UNITED STATES PATENT AND TRADEMARK OFFICE  
**CERTIFICATE OF CORRECTION**

PATENT NO. : 6,803,717 B2  
DATED : October 12, 2004  
INVENTOR(S) : Tomoya Ohnishi

**FIG. 11**  
PRIOR ART

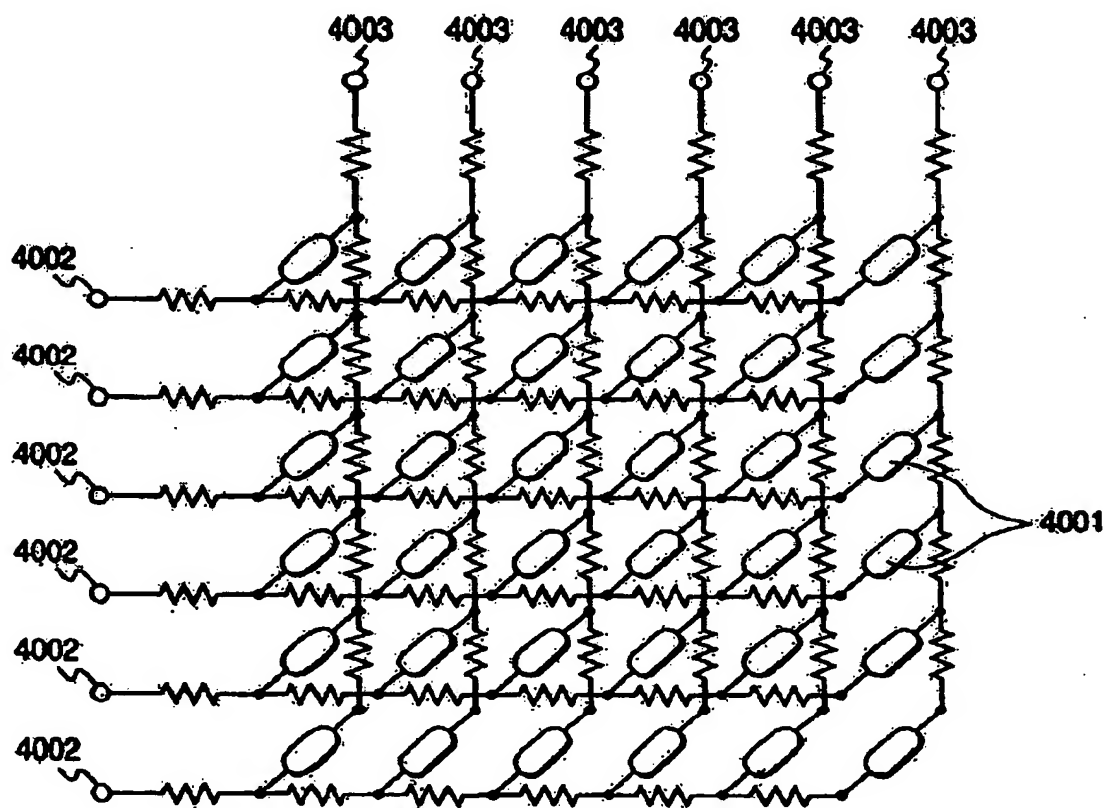
Delete Drawing Sheets 2, 8, 9 and 10 consisting of FIGS. 2, 11, 12 and 13, and replace with the attached drawings.
